Request:
Major Site Plan to
construct 7 duplex villa
buildings

| Hudson Planning Commission | SITE PLAN REVIEW – LAUREL LAKE VILLAS |
| Case No. 25-229 | September 8, 2025 |

Re: Laurel Lake – Addition of Units
Conditional Use Request
Viewpoint #25-229

September 8, 2025 PC Submittal
Demolition/ Tree Clearing Plan

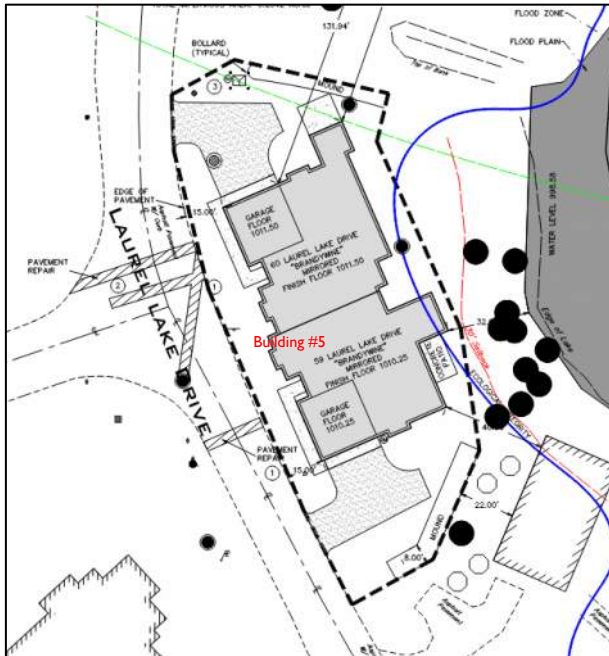
1. Building #2 has been redesigned back to a single unit; however, the project limits have a minor deviation within the Index of Ecological Integrity and the demolition plan below depicts tree removal within the IEI limits. The applicant should ensure the depicted project limits capture all proposed work.

Trees proposed to be
removed within IEI

June 9, 2025 PC Submittal

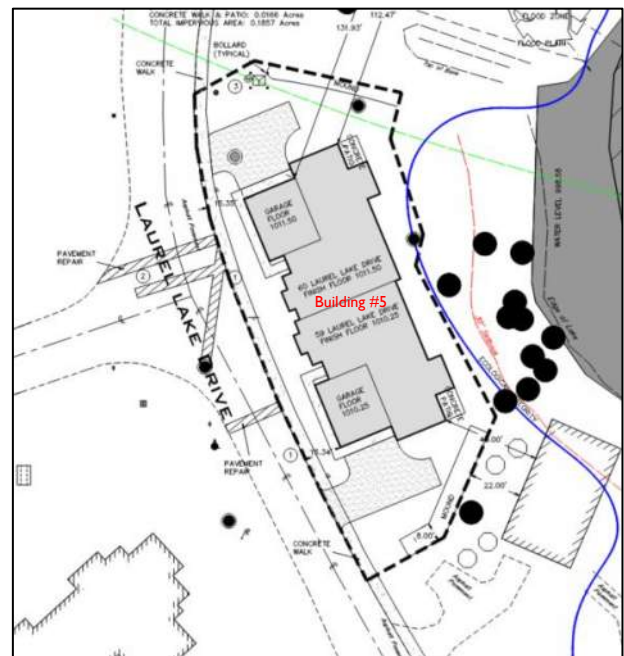
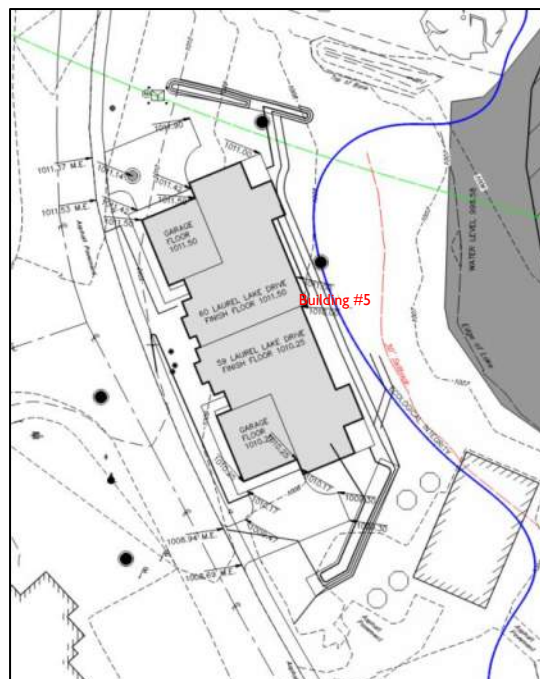
2. Building #5 footprint has been reconfigured to reduce disturbance into the IEI; however, the project limits plan and site grading plan below depict minor disturbance/grading within the IEI limits. Additionally, staff has identified a tree adjacent to the project limits that is noted to be preserved; however, preservation does not seem feasible due to its proximity to the proposed grading and building. Staff suggests revising the site plans to show removal.

Staff Comments – Buildings 1 & 2

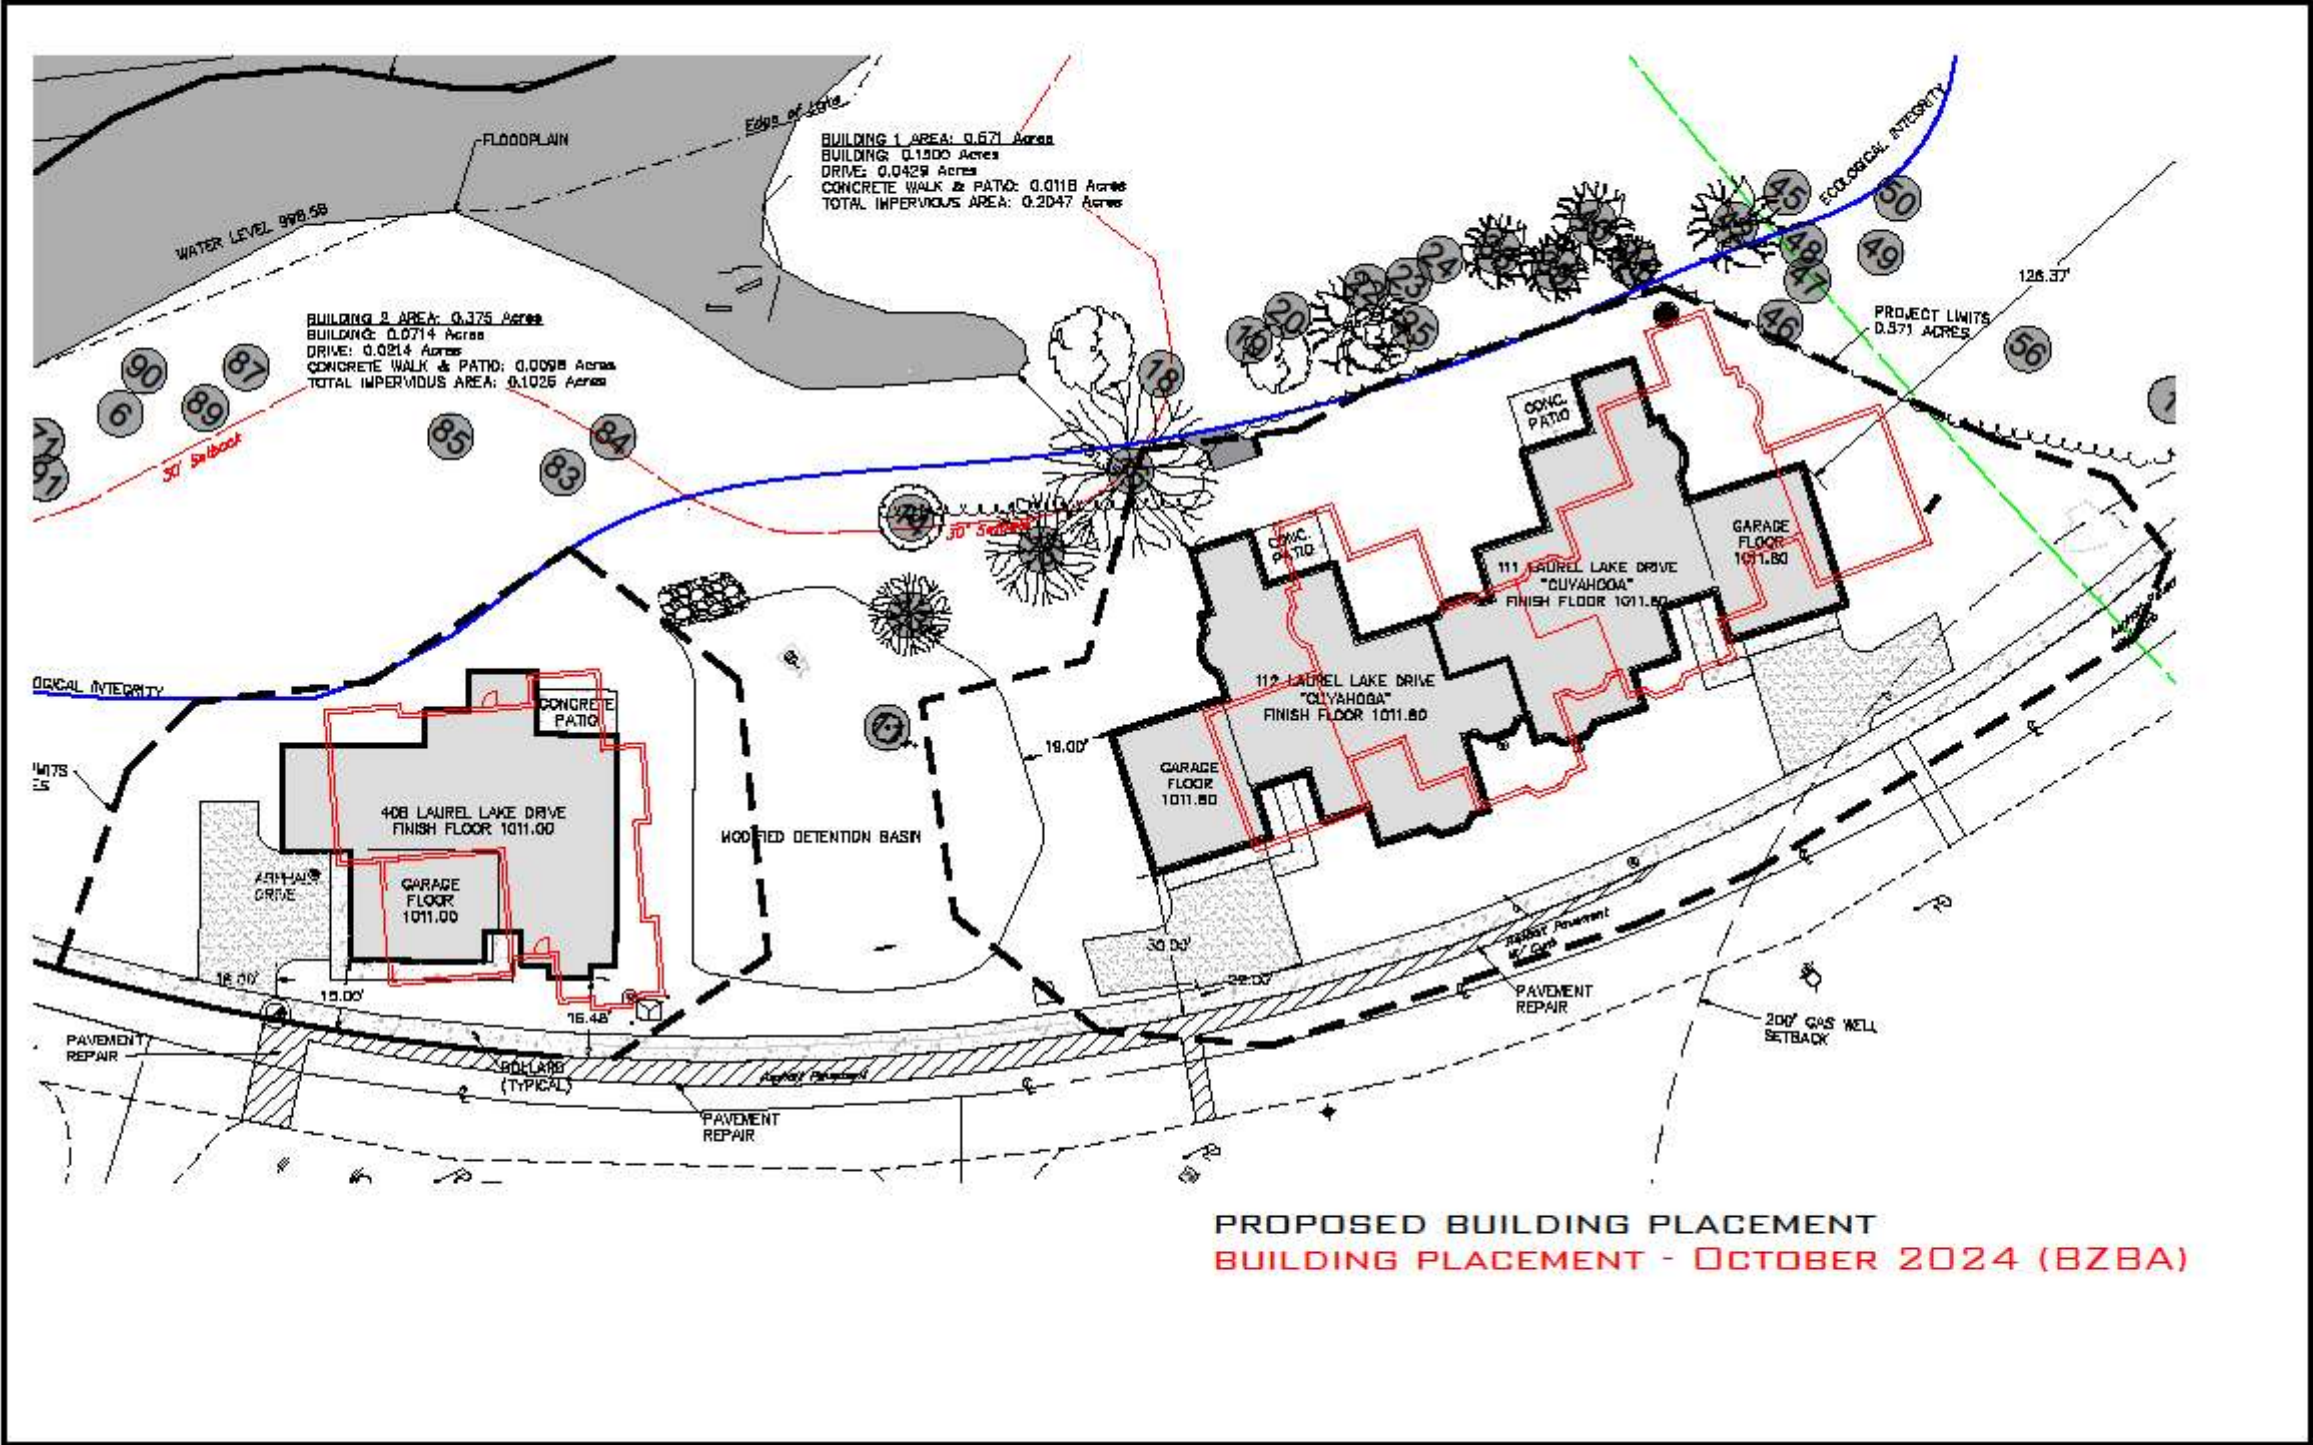
1. Building #2:
 - a. Project limits and tree removal extend into the Index of Ecological Integrity (IEI).
2. Building #5
 - a. Project limits and grading extend into the Index of Ecological Integrity (IEI).

Staff Comments – Building 5

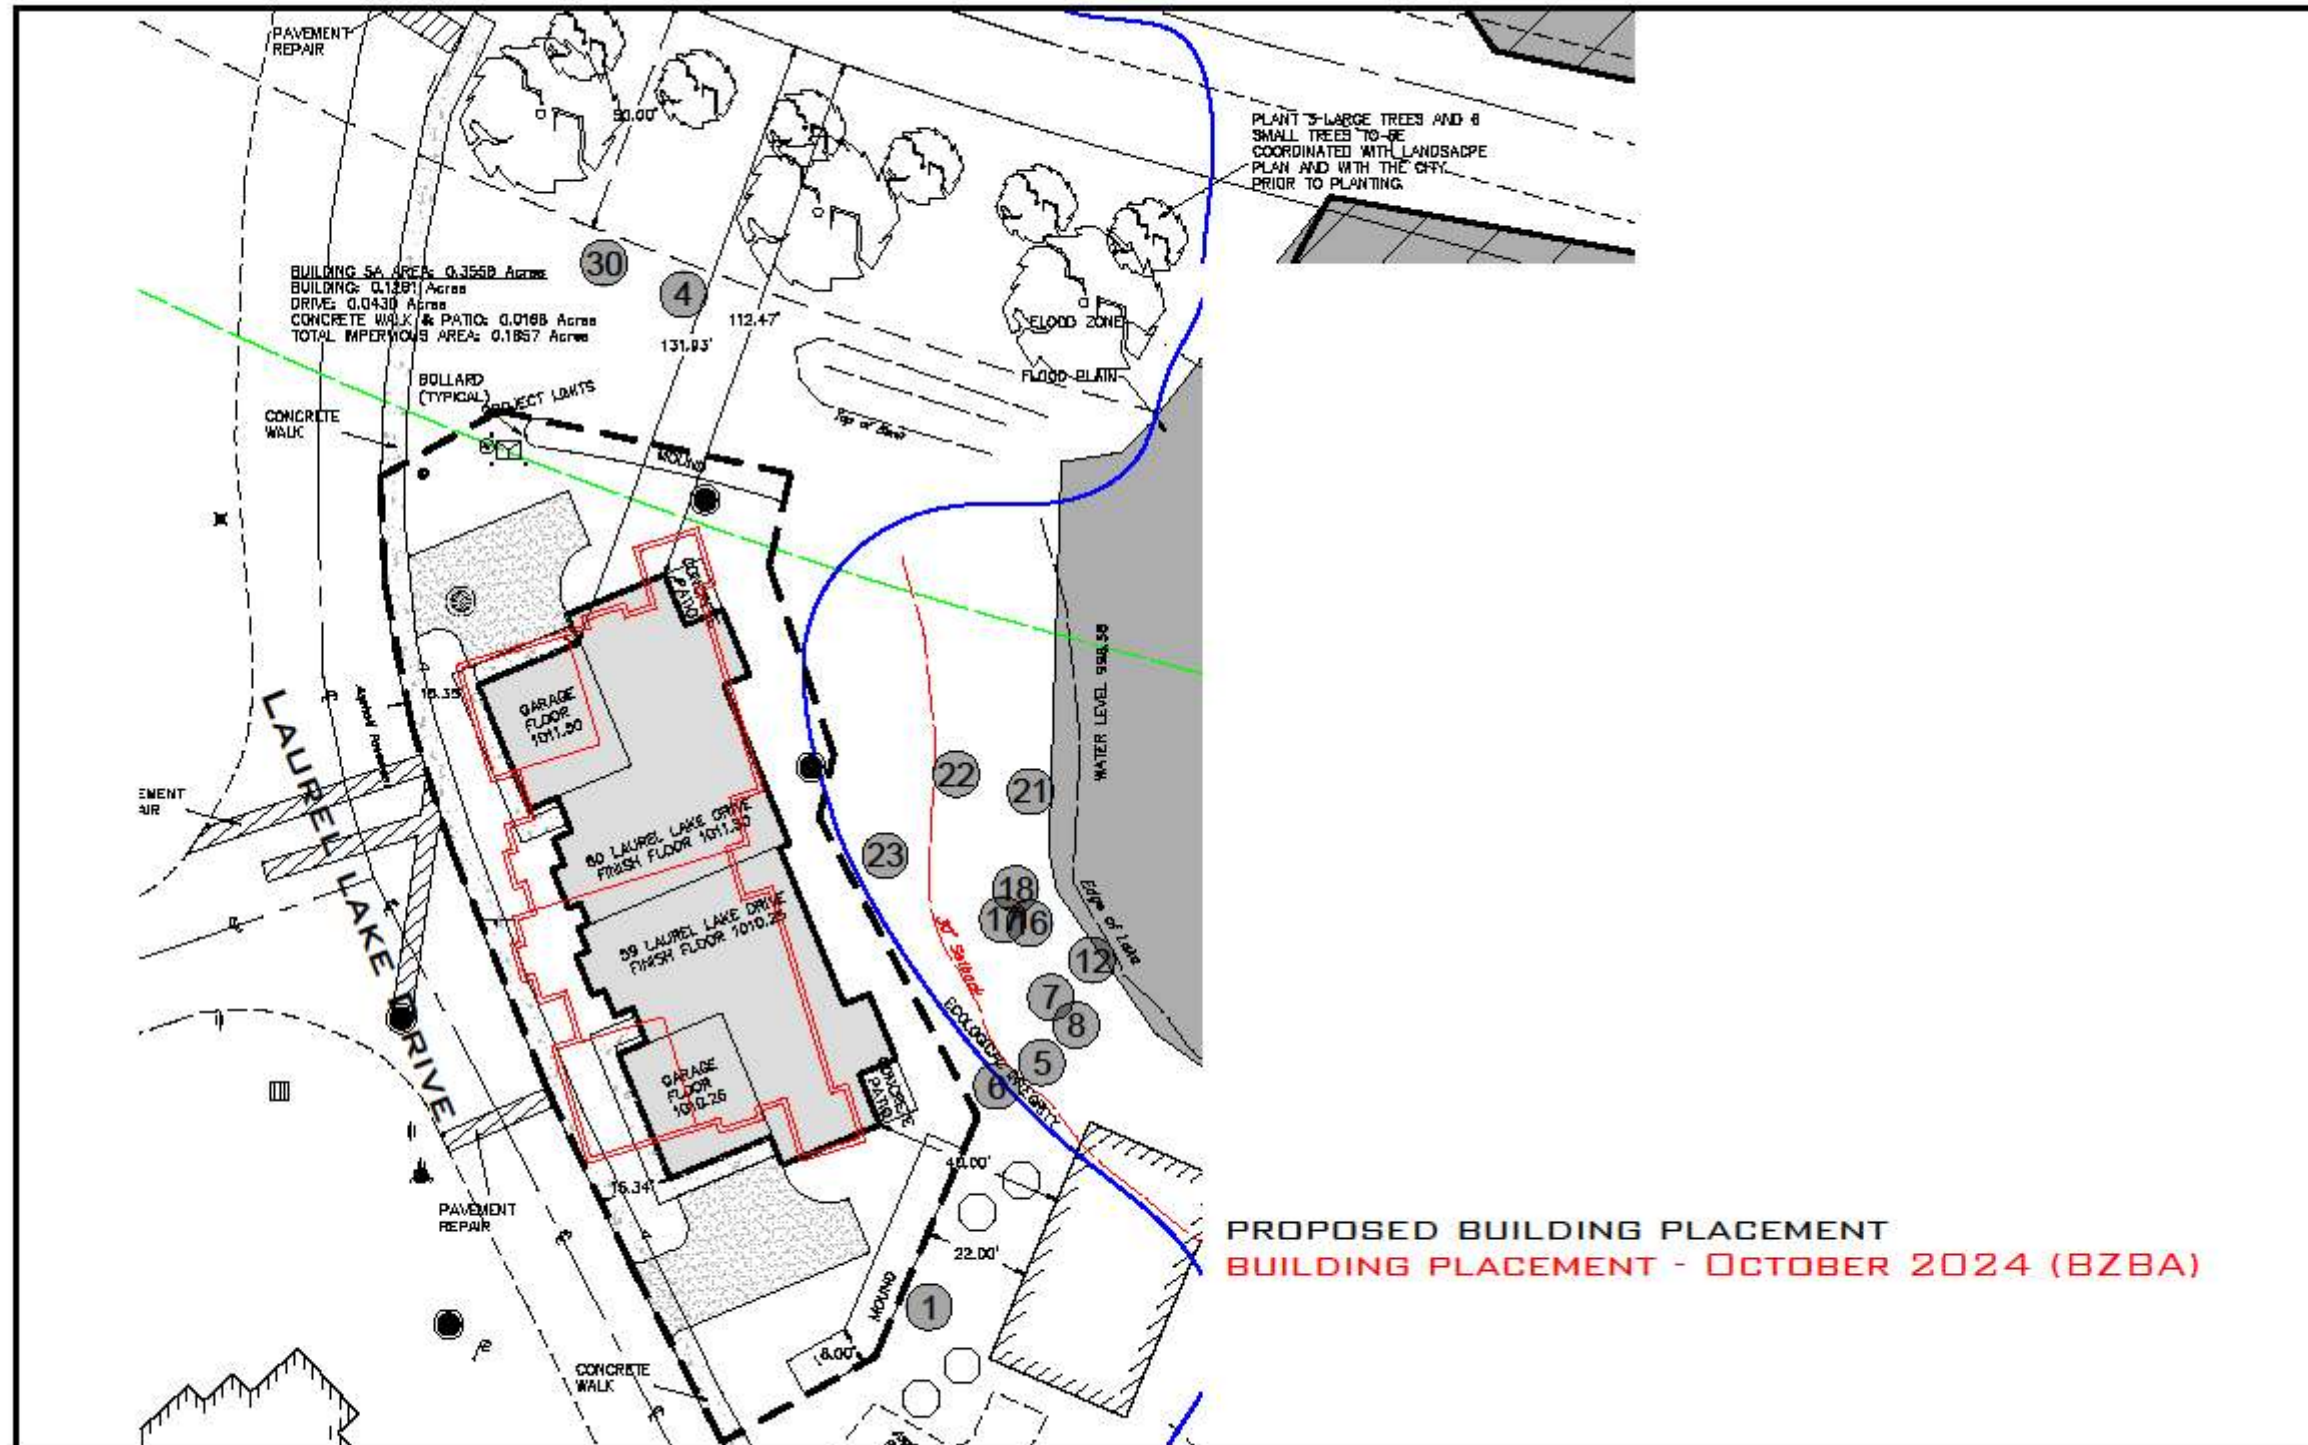
- b. Tree identified adjacent to grading/project limits.
3. Buildings #8 and #9:
 - a. A separate floodplain application is required for review by the City's Floodplain Administrator per Section 1205.14.
